# Addendum 1

Date: March 12, 2018  
Parks Canada  
V/REF.: CLAC-899-05  
Project: HALL AND WELLINGTON PEDESTRIAN BRIDGES REPLACEMENT – WORK 2017-2018

Project: HALL AND WELLINGTON PEDESTRIAN BRIDGES REPLACEMENT – WORK 2017-2018

**Appendix 1**  
**CLAC-899-05-L.001-Wellington drawing**

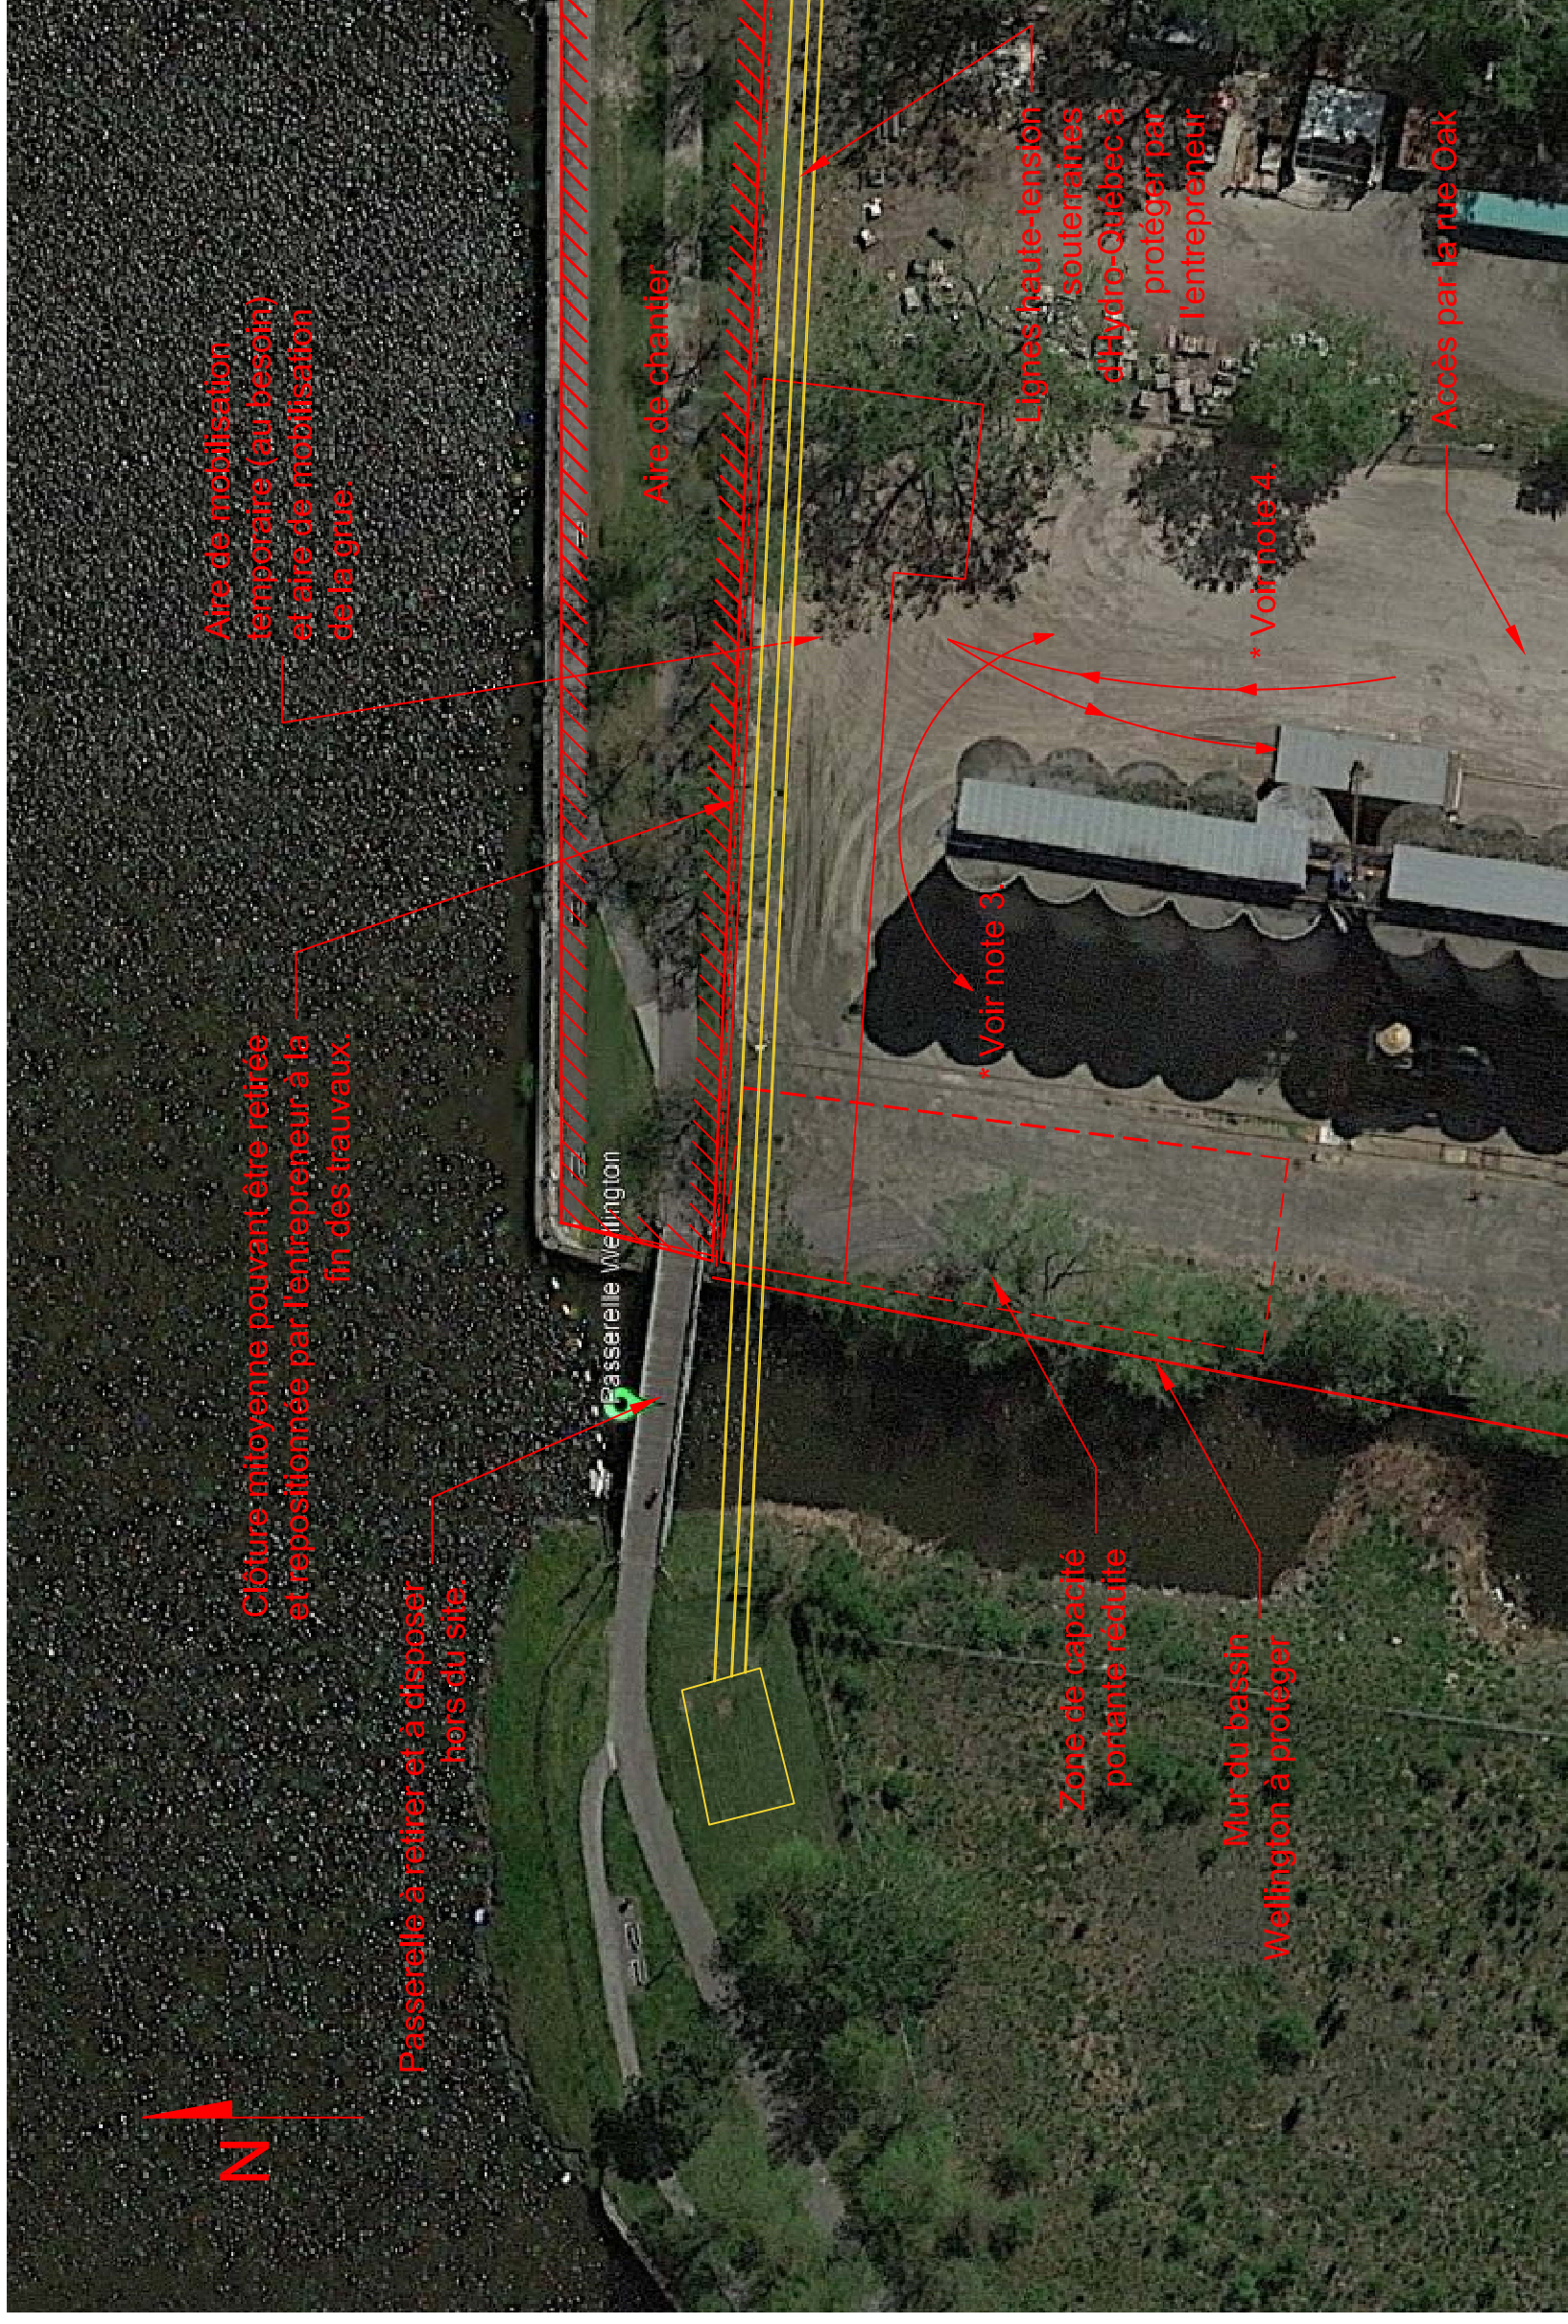
- .4 However, the Contractor may make an agreement with the riparian owners for his needs and those of the worksite (temporary access roads, waste areas, temporary construction areas, etc.). A copy of the agreements signed between the parties must be given to the Engineer before any use of spaces outside the areas identified in the plans and specifications. The Contractor is advised that Parks Canada has obtained an agreement with the owner of the land adjacent to the Wellington pedestrian bridge, located along Oak Street, belonging to the Port of Montreal, but operated by Parrish & Heimbecker Milling (tenant of the land). For site requirements such as the construction of temporary access roads and temporary construction areas, this land may be used by the Contractor under the following conditions:

- .1 The portion of the railway located at the north-west direction from the silo building may be used if ensuring adequate rail protection with metal plates or other;

- .2 The portion of land between the railway and the basin, located westward, has a reduced bearing capacity. The Contractor must adapt his working method accordingly;

- .3 A corridor between the construction site and the silo building shall permit the passage of a medium-sized wheel loader (CAT 982M model or equivalent) at all times;

- .4 The occupation of the lot must allow for delivery operations of 53 feet long trailers, including the tractor, in the hangar adjacent to the silo building located on the east side;

- .5 The buried Hydro-Québec line must be protected during the works;
- .6 The adjoining fence between the PCA property and the Port of Montreal property could be removed during the construction work and repositioned by the Contractor at the end of the work. Site safety shall be provided by the Contractor's site facilities during the construction work period;

- .7 The land and facilities must be returned in the same condition as the one before the occupation for the work;
- .8 Details of this land and its permitted occupancy are provided in drawing CLAC-899-05-L.001-Wellington, presented in Appendix 1 of the present document.
